PCN – Product Change Notification

PCN-A-110115

PCN Topic: W19 LCD Housing change

New Mechanical Dimension (W19L300-OF M1):

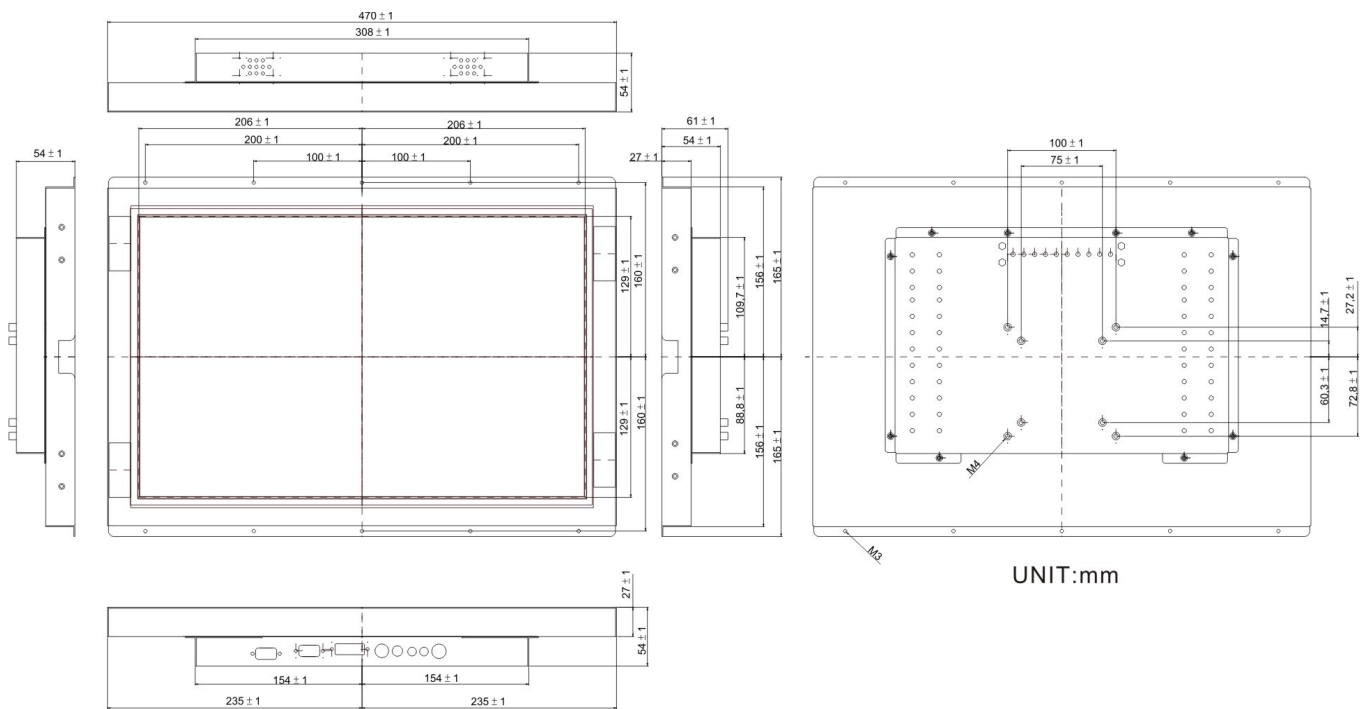
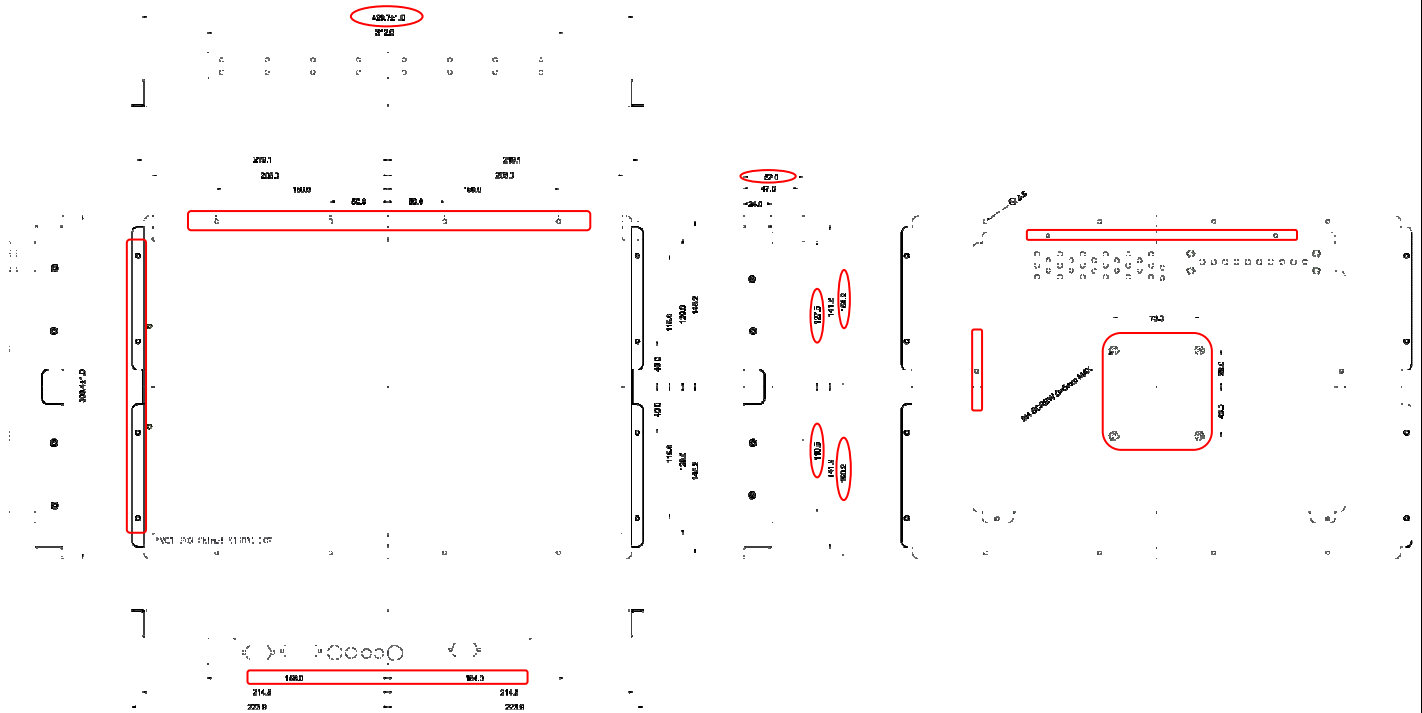
Resistive Touch: The dimension of open frame mechanical will change from 470 X 330 X 61mm to 429 X 300 X 52 mm.

Front side dimension change:

- 1.length: 470mm(old) => 429mm(new)
- 2.wide: 330mm(old) => 300mm(new)
- 3.high: 61mm(old) => 52mm(new)
- 4.lockhole:(old)5 up-side & 5 down-side
=>(new)4 up-side & 4 down-side & 4 right-side & 4 left-side

back side dimension change:

- 1.length: 308mm(old) => 312mm(new)
- 2.wide: 198.5mm(old) => 238mm(new)
- 3.high: 27mm(old) => 23mm(new)
- 4.lockhole: (old) 4 up-side & 2 down-side & 2 right-side & 2 left-side
=>(new) 2 up-side & 2 down-side & 1 right-side & 1 left-side
